**Proposed Route
Alternatives Considered
Buffalo Ridge to White
115 kV Transmission Line
Xcel Energy
Windfarm Transmission
Improvement Projects**

**In the Matter of Xcel Energy's
Application for a Route Permit for the
Buffalo-White High Voltage
Transmission Line, the new Yankee
Substation, and Associated Facilities in
Lincoln County, Minnesota**

**ENVIRONMENTAL ASSESSMENT
SCOPING DECISION
EQB Docket # 04-84-TR-XCEL
November 1, 2004**

Figure A

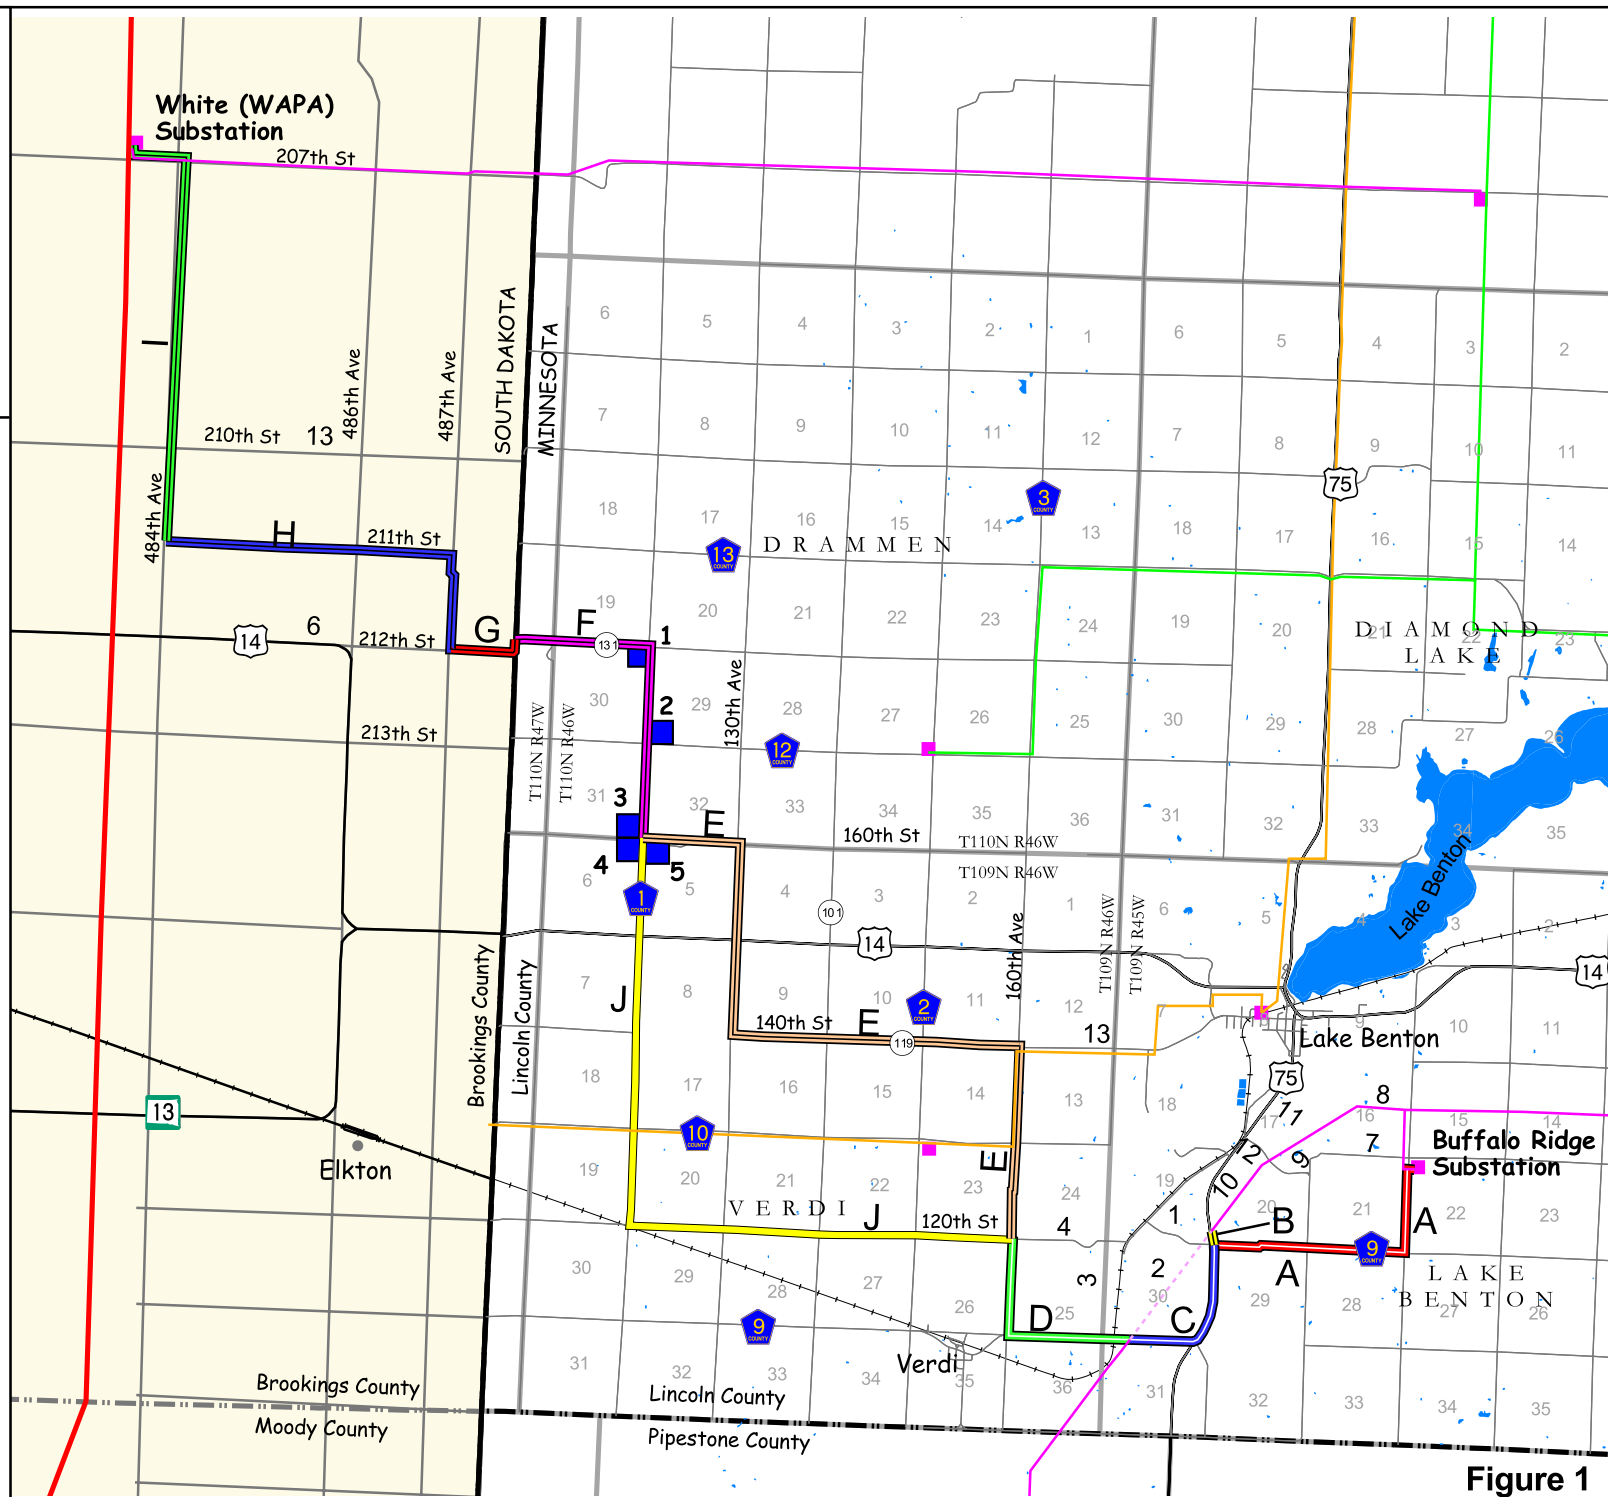
1. The route proposed by Xcel Energy shown as segments A, B, C, D, E, and F) in Figure 1. Route segments G and H are located in South Dakota and not subject to EQB review. However, they will be discussed in the EA.

3. Substation Sites. The EA will also evaluate the five proposed Yankee Substation sites located in sections 31, 29 and 30 in Drammen Township and in sections 5 and 6 in Verdi Township, as shown in Figure 1.

The EQB will not evaluate any route segments through the Hole-in-the Mountain Prairie owned by the Nature Conservancy or the Hole-in-the Mountain Wildlife Management Areas managed by the Minnesota Department of Natural Resources because of their unique characteristics and objections expressed by the Nature Conservancy and DNR.

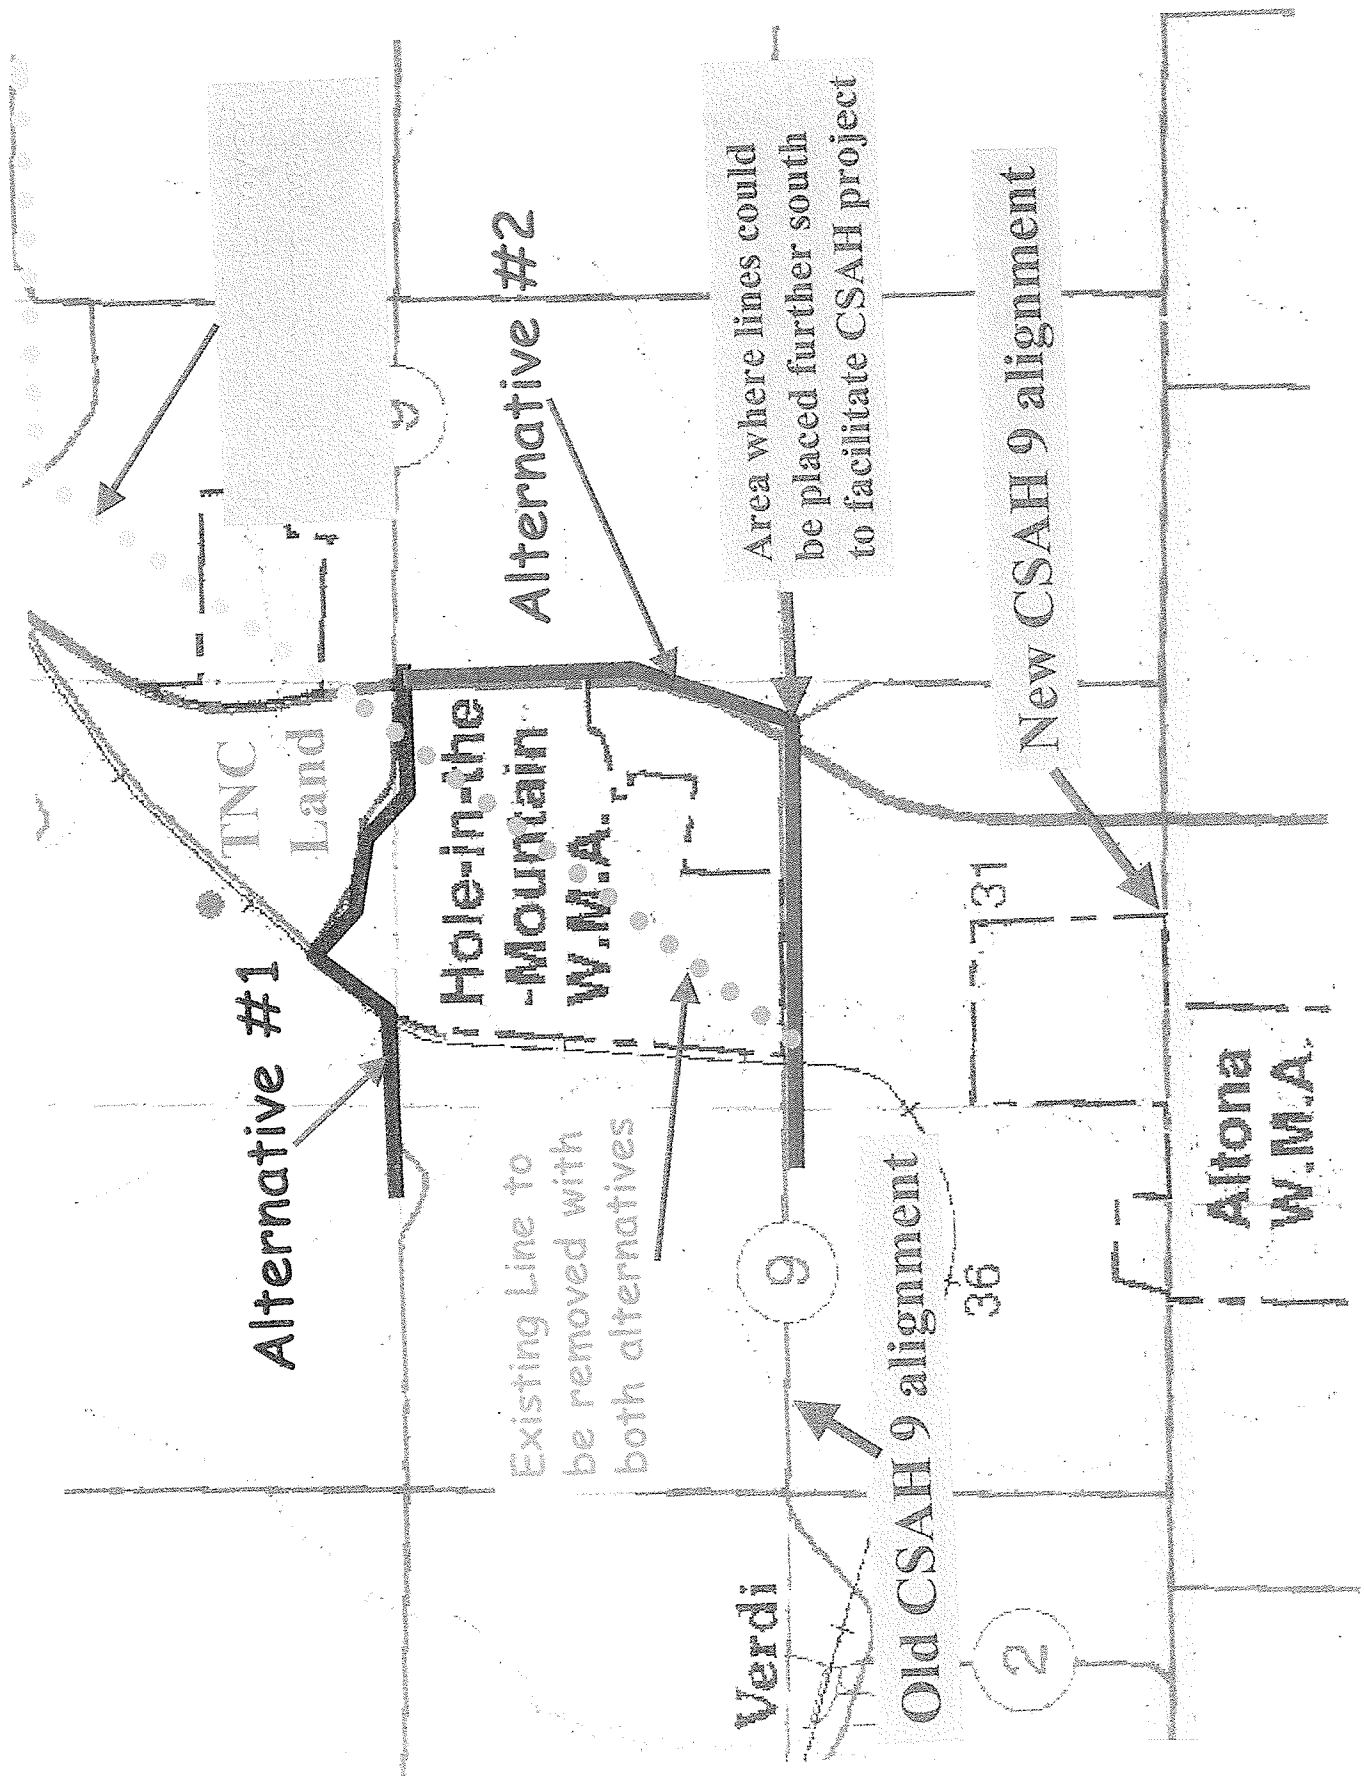
I have attached a map showing alternative 1 and alternative 2 as we had discussed them at our initial meeting. I will refer to these two options as alternatives 1 and 2 in the following discussion.

Alternative 1 initially appeared to be the best route – shortest in distance and facilitated the removal of significant portions of existing power lines. I have denoted on the map what DNR understood to be power lines available for removal with alternative 1. DNR and TNC were both supportive of alternative one, but agreed that we would need to fully discuss this option with our staff to determine if it was both feasible and favorable.

Alternative 2 was also suggested as a reasonable option. This option would utilize existing corridors where transmission line disturbance was already present and still provide the opportunity to remove some existing lines from the WMA (again see the attached map). Although alternative two is longer, thus requiring more line, it was also viewed as less impacting

After additional discussion with TNC staff and a series of internal DNR discussions, DNR determined that our preferred alternative was 2. Several DNR staff expressed significant concerns about the potential impacts of alternative 1. These impacts included, but were not limited to:
